ADDENDUM NO. 03

**Westfield Washington School Corporation
Westfield Middle School West (Site Package)
17707 Centennial Road,
Westfield, IN. 46074**

PROJECT: Westfield Middle School – West (Site Package)

DATE: June 24, 2024

10 SYNTHETIC TURF - TYPICAL SECTION
Scale: 1-1/2" = 1'-0"

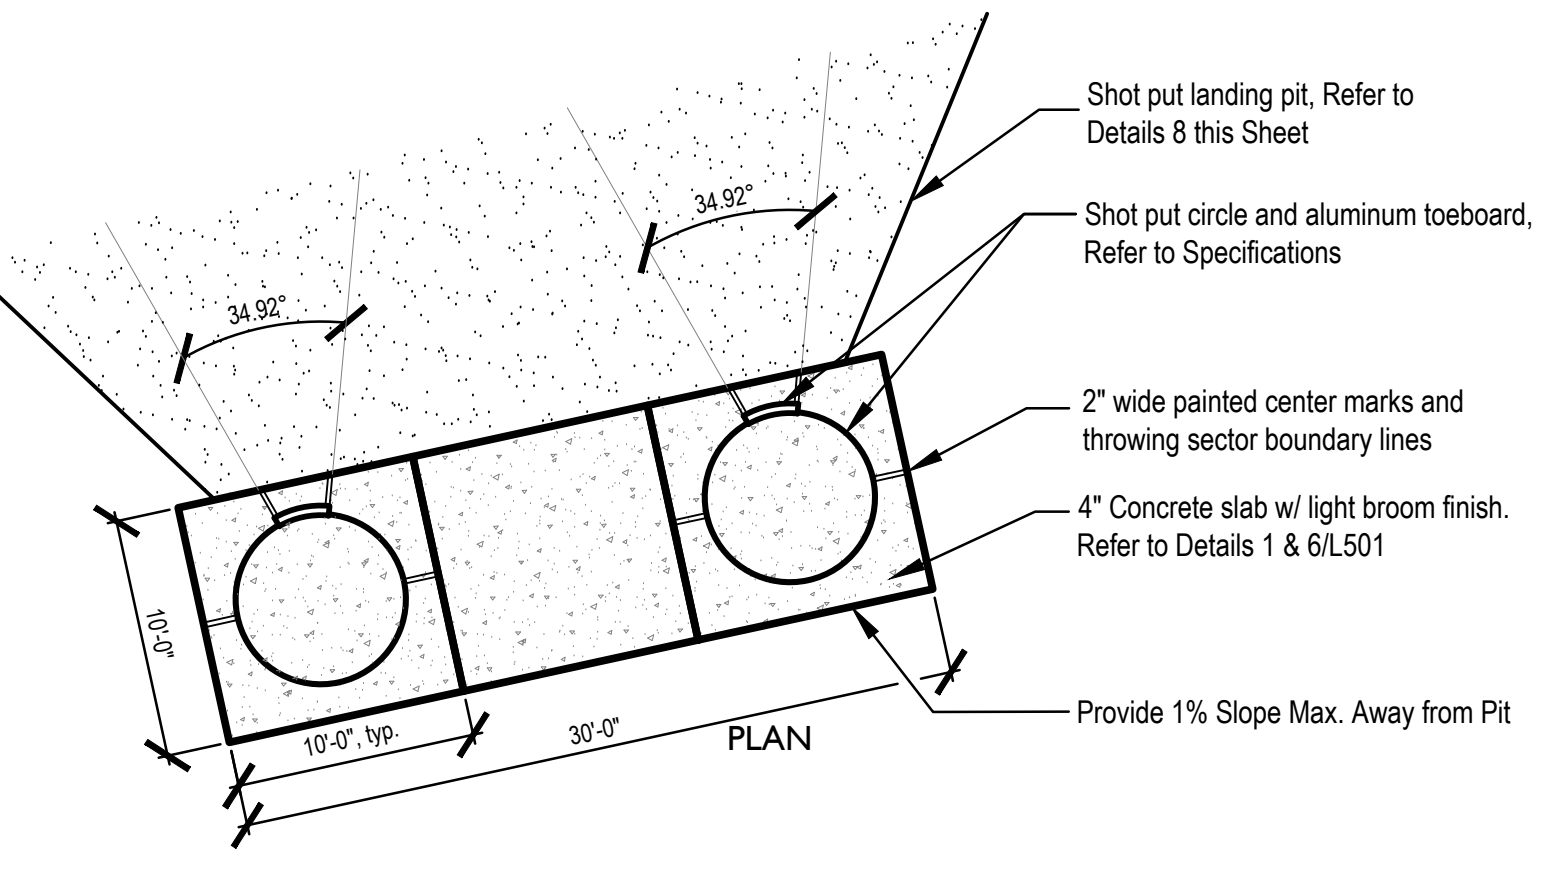
06.03.2024	30a	Cross Section	Please provide a cross section for the running track		See Detail 2 / L513 (fjp)	Fred P	Fred P	#02	Done
06.03.2024	30b	Cross Section	Please provide a cross section for the football field (if synthetic option is pursued; 0.5% cross slope)		See Detail 10 / L513 (fjp)	Fred P	Fred P	#03	Done
